MFN 06-264

Docket No. 52-010

Subject: Response to Portion of NRC Request for Additional Information Letter No. 18 Related to ESBWR Design Certification Application - Containment Design - RAI Numbers 6.2-9, 6.2-13, 6.2-32, 6.2-33, 6.2-35 through 6.2-39, and 6.2-41 through 6.2-47

**Response to Portion of NRC Request for
Additional Information Letter No. 18
Related to ESBWR Design Certification Application
Containment Design
RAI Numbers 6.2-9, 6.2-13, 6.2-32, 6.2-33,
6.2-35 through 6.2-39, and 6.2-41 through 6.2-47**

Figure 6.2-18 (continued). RWCU/SDC System Subcompartment Pressurization Analysis (Sub-Model 2)

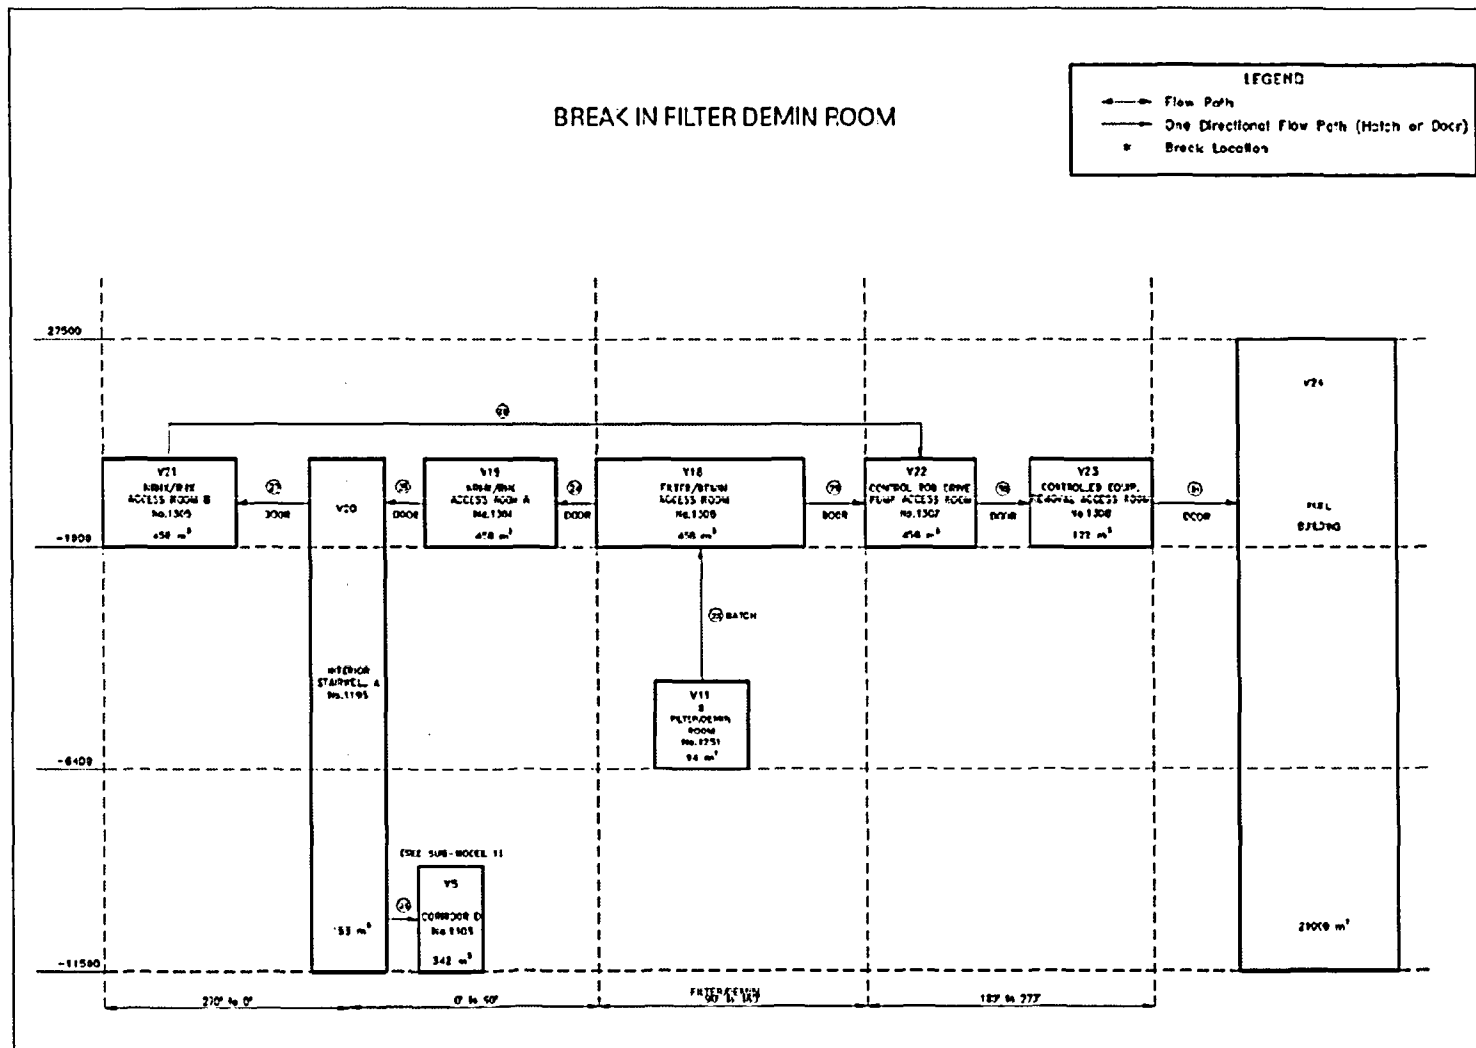
DCD Figure 6.2-18 is called typical. In addition, there is a reference on the figure to a "sub model 2." This models does not appear to be in the DCD, provide it. For each applicable subcompartment, provide figure(s) of the model(s) and the results of the analyses.

The required information will be included.

DCD Figure 6.2-18 will be updated in the next issue as noted in the attached markup.

Figure 6.2-19 Pressure Histories due to Break Case 1 in Cell 1 (Sub-Model 1)

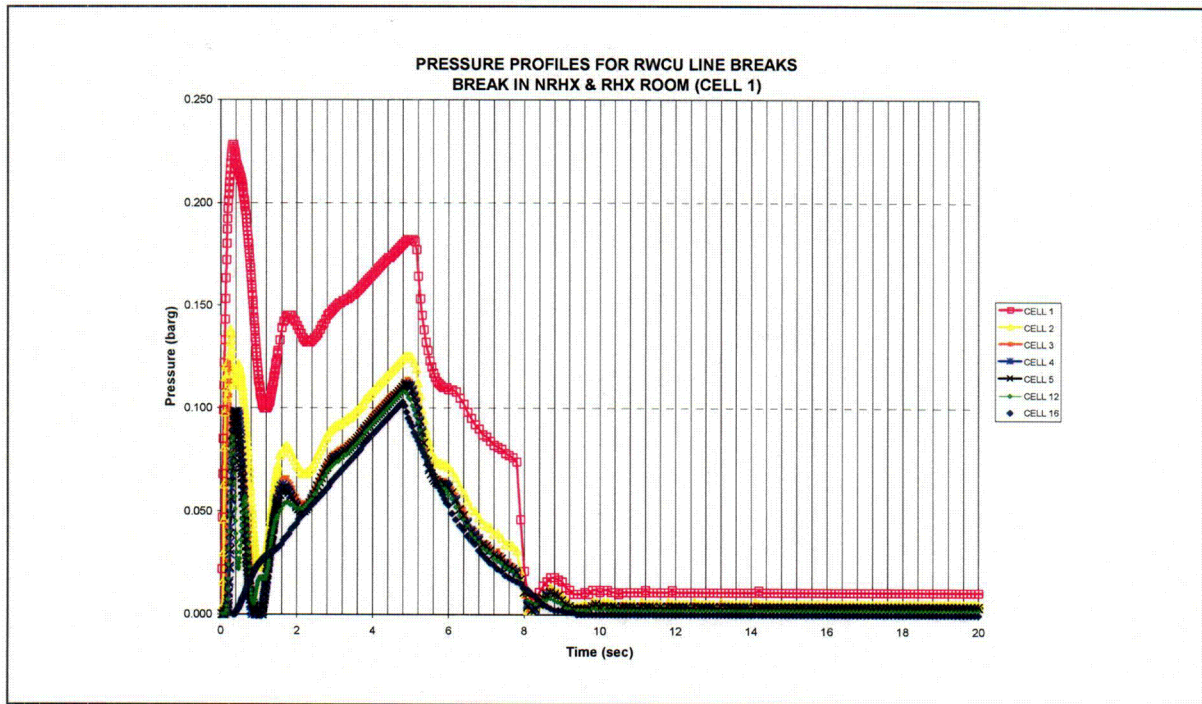
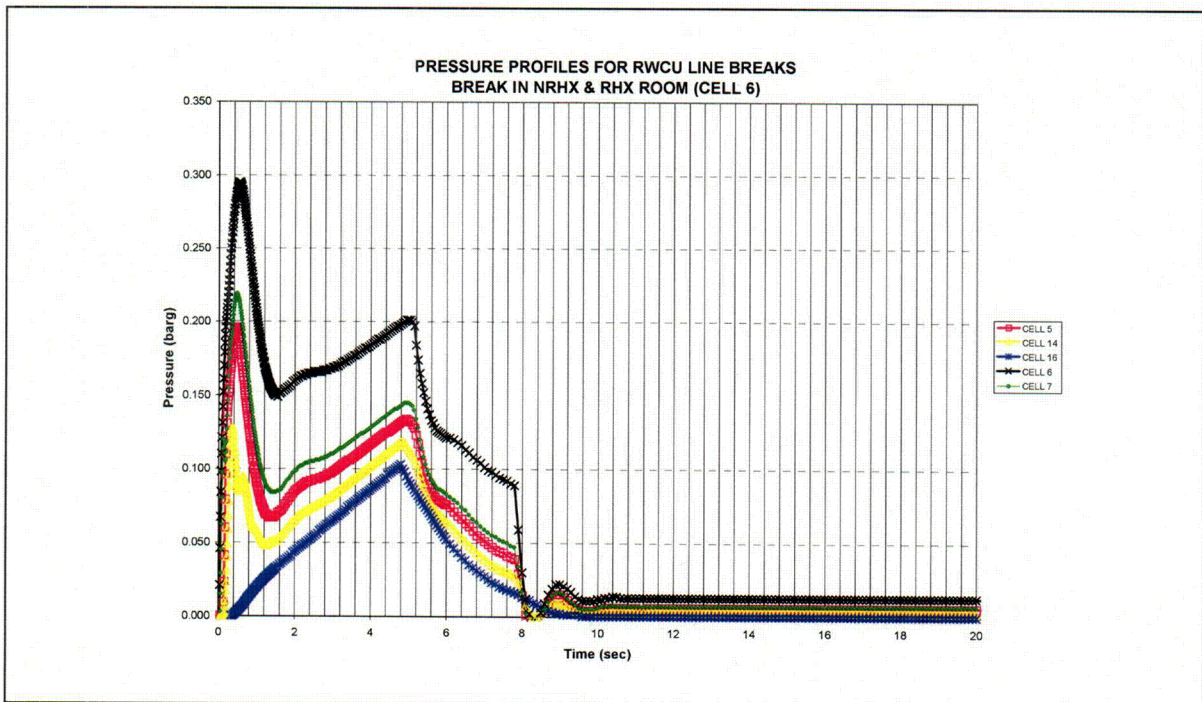
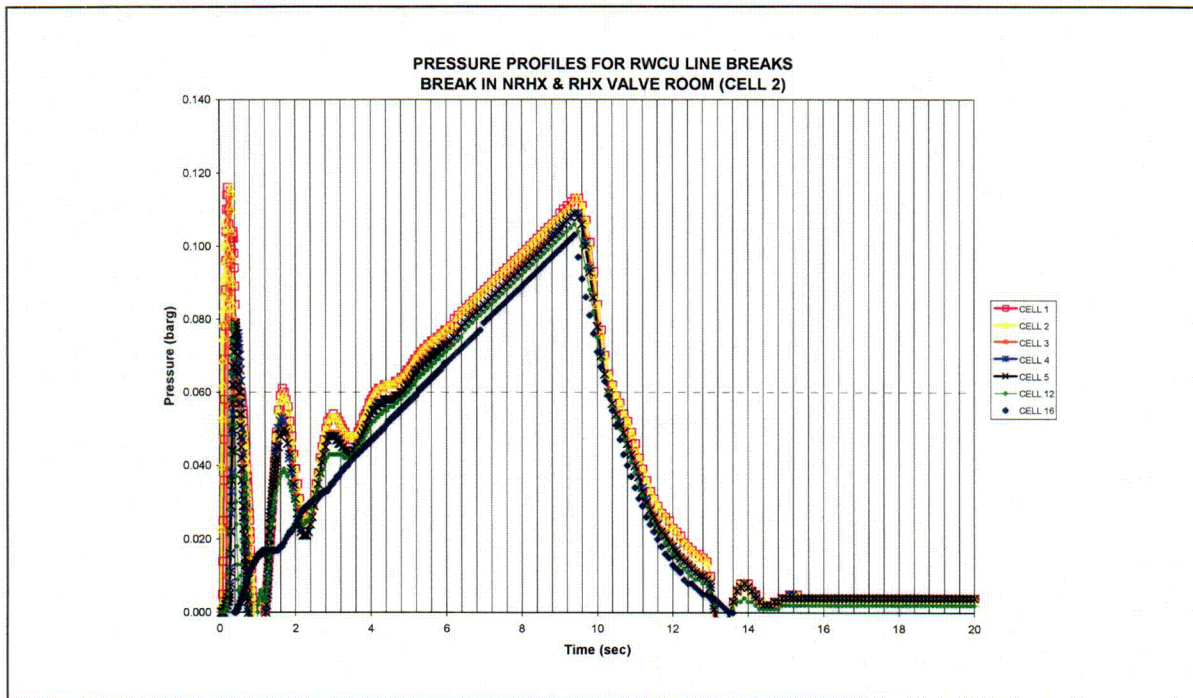
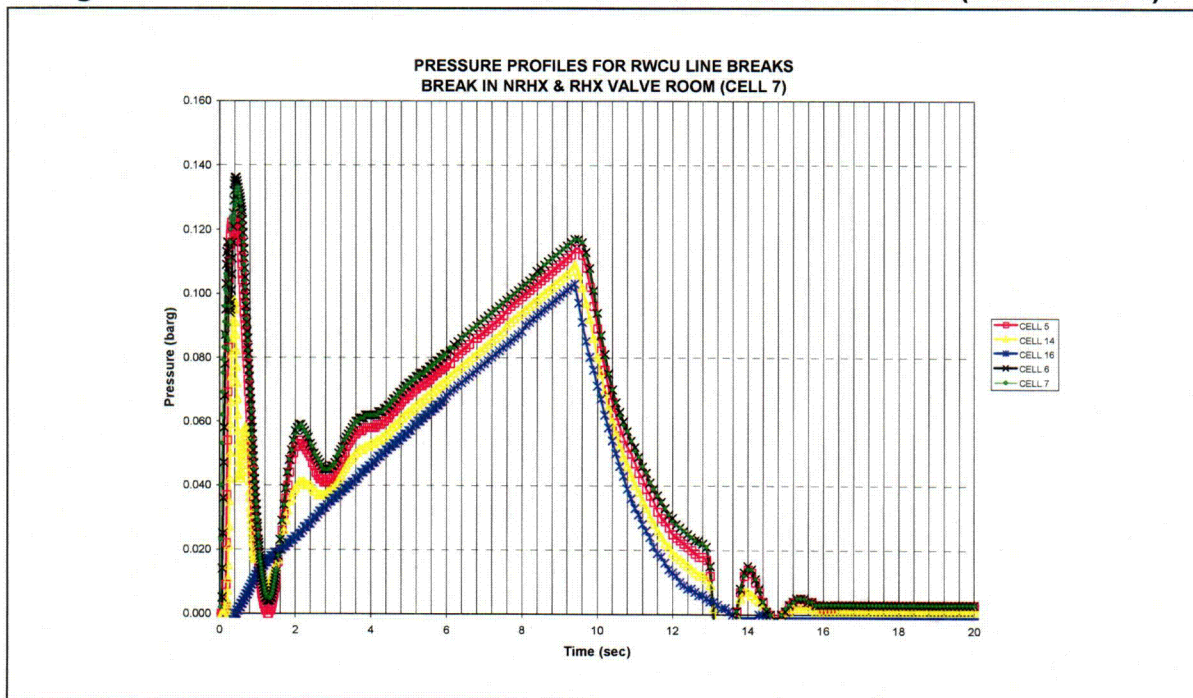
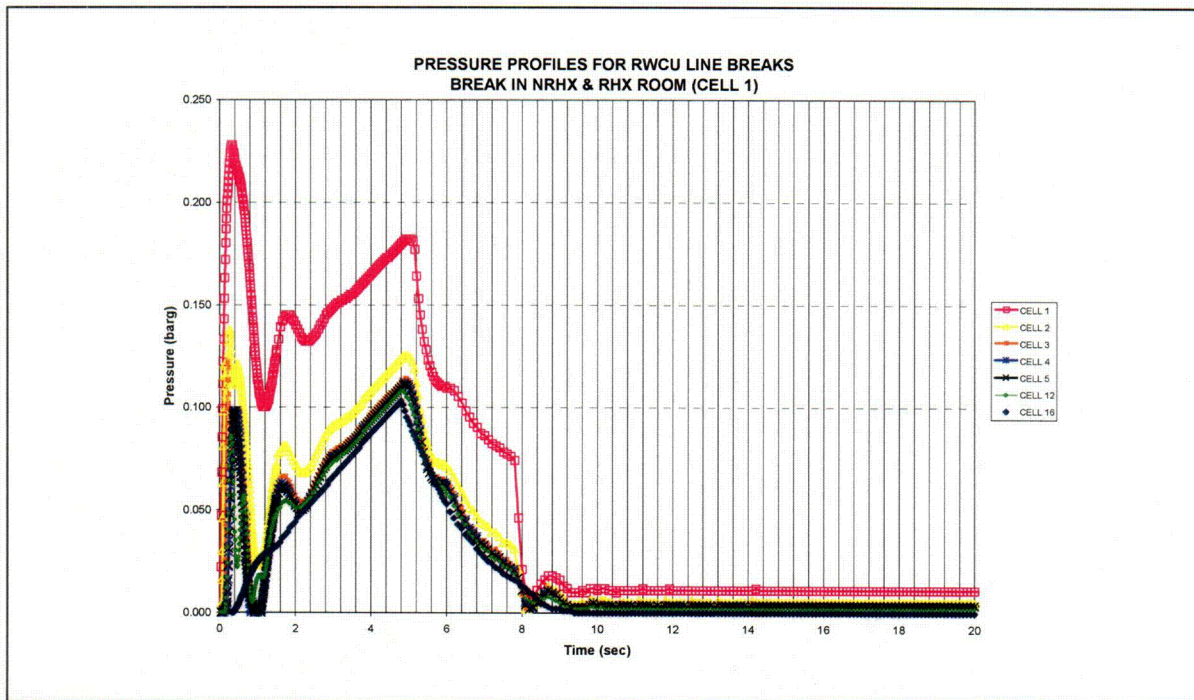
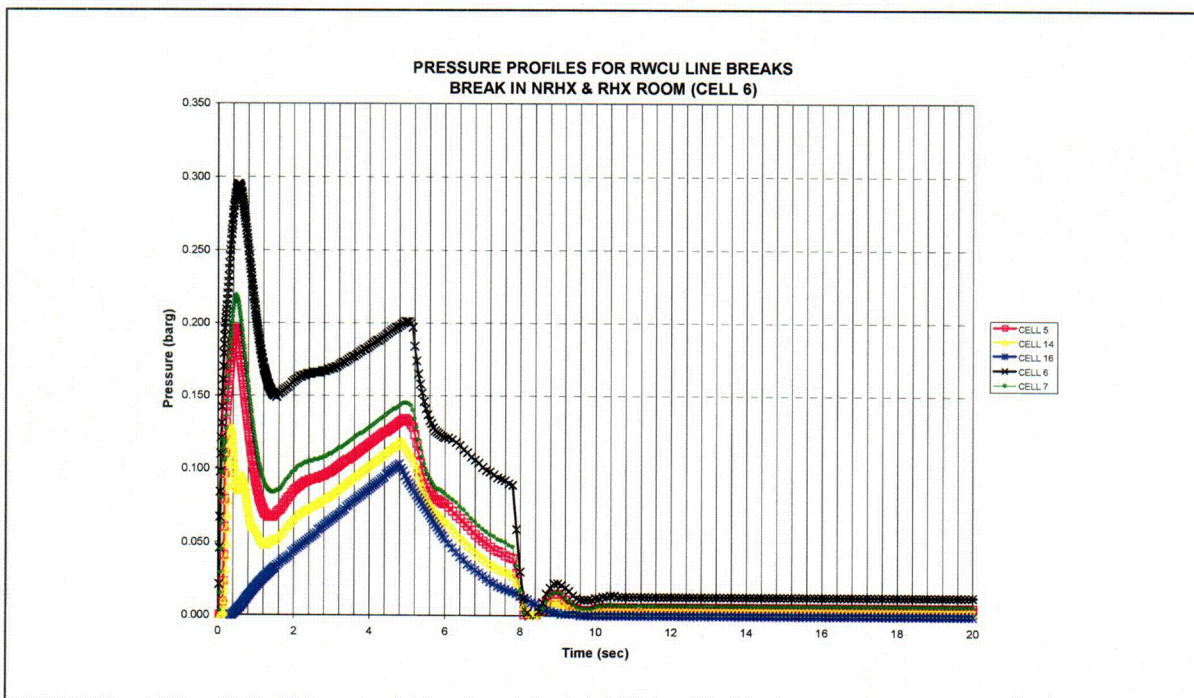
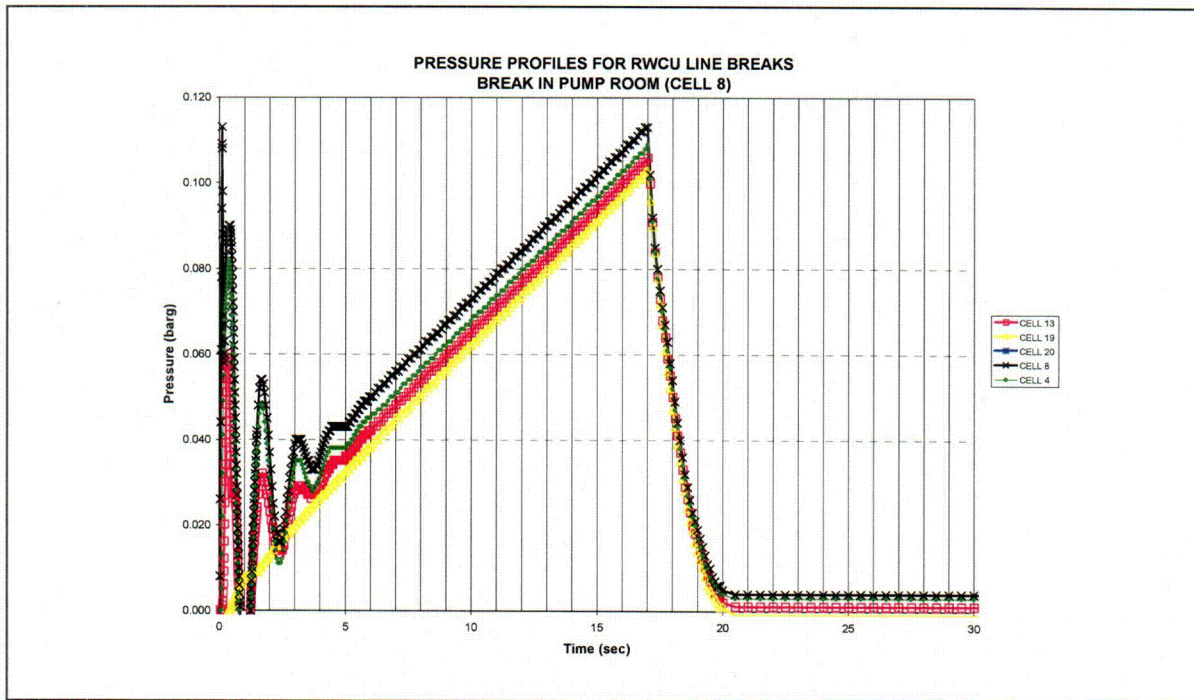
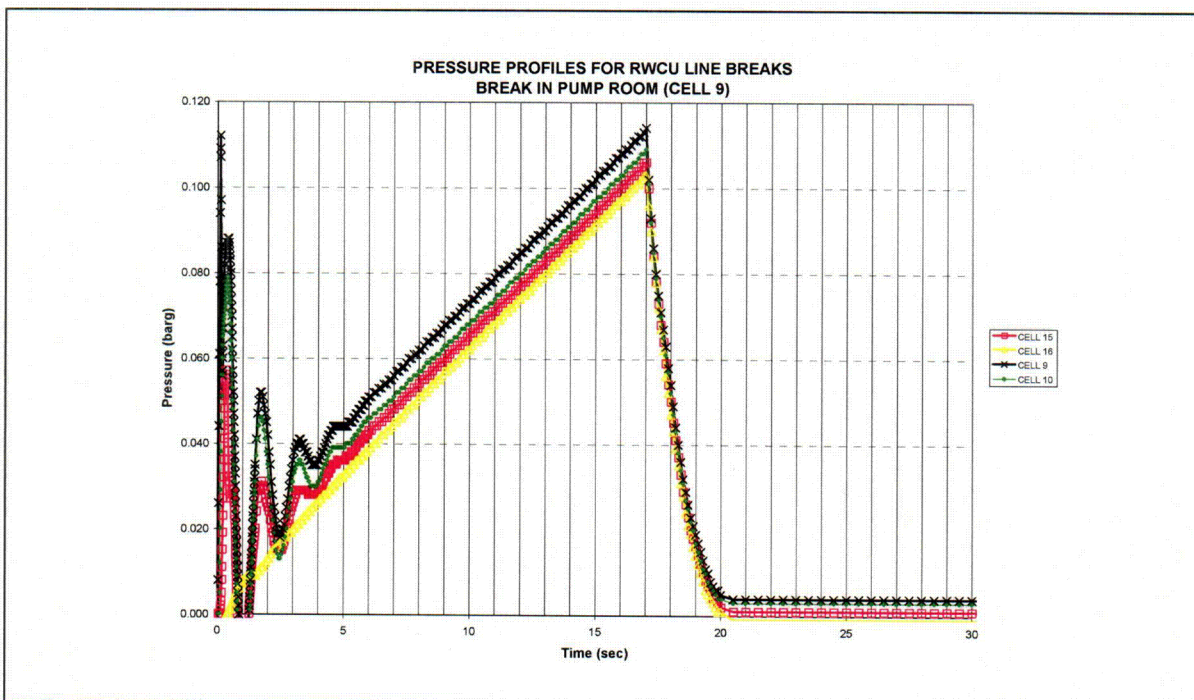
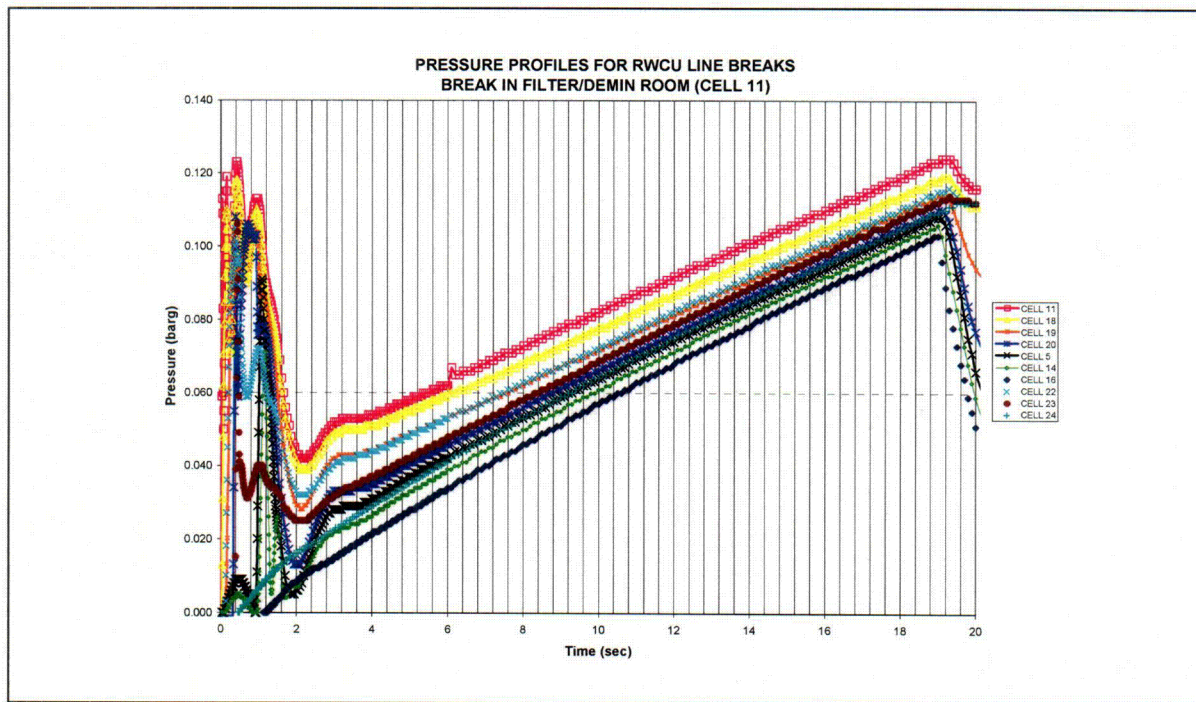
Provide graphs of the pressure responses of all subnodes within a subcompartment as functions of time to permit evaluations of the effect on structures and component supports. Provide this information as part of DCD Tier 2, Section 6.2.1.2.3, "Design Evaluation." This information is necessary to evaluate ESBWR subcompartment loads per SRP 6.2.1.2 and RG 1.70, Section 6.2.1.2..

The required information will be included.

Figures 6.2-19 through 6.2-27 will be added in revision 2 of the DCD.
